DATE: 10.14.2015
TO: ProTrak
FROM: Bill McDow
Transportation Planning

■ **AUTOZONE OLEANDER [TRC Plan Review]**

↻ Initial Review Note ↻

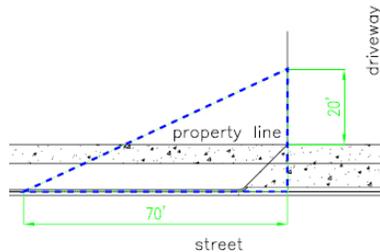
1. Driveways for lots along major thoroughfares must at least 75’ offset from property lines to the curb line. The property has adequate clearance on the eastern property line, however, the western property line appears to be too close.
2. The driveway curb return must be at least 26’ from intersecting property lines at the street corner as measured in accordance with CofW Standard Detail 8-07. [\[Chapter VII, C, Table 5 Note #6. CofWTSSM\]](#)
